TECH TIP

Group:	48-SUSPENSION
Bulletin No:	TT-16-010
Issue Date:	11-9-2016
Reference:	HMM-140401-F1

AIR SPRING SHIELD

SUBJECT VEHICLES: 06MY-17MY Conventional Trucks equipped with a Comfort Ride rear air suspension

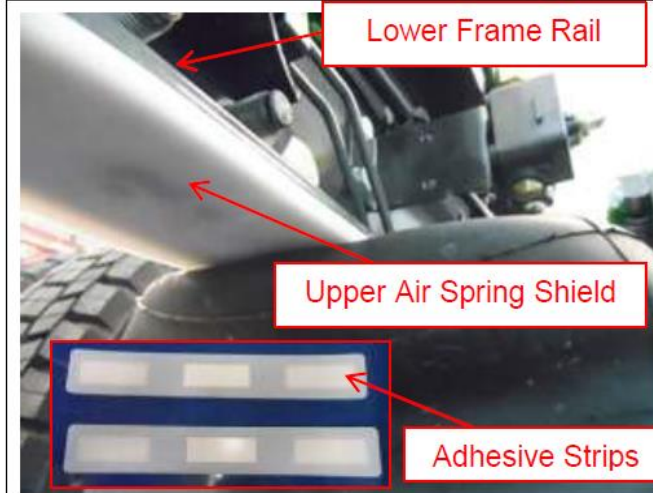
Severe chafing between the rear air spring and frame rail resulting in failure of the air spring.

An upper air spring shield is available to provide additional protection against chafing between the frame and air spring. The upper air spring shield will be positioned between the vehicle frame rail and the air spring upper mount.
